## TECHNICAL SERVICE BULLETIN

**REFERENCE:** IMH4100DT / IMU3100KT Mobile Radios

**SUBJECT:** Receiver Front-End RF Overloading  
**(Replaces TSB NO. 233)**

SCHEMATIC DIAGRAM

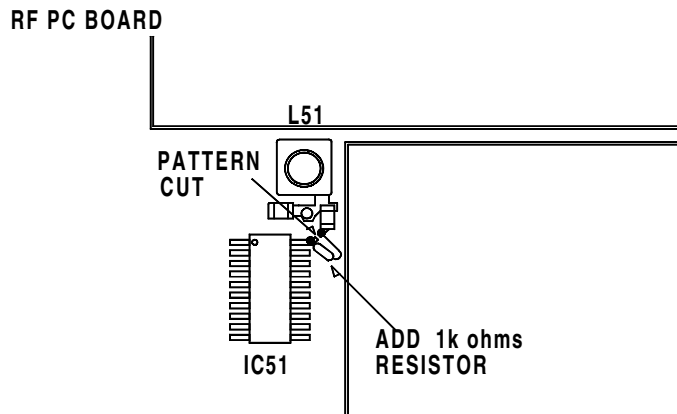
1. Cut Trace
2. Add 1k ohm resistor
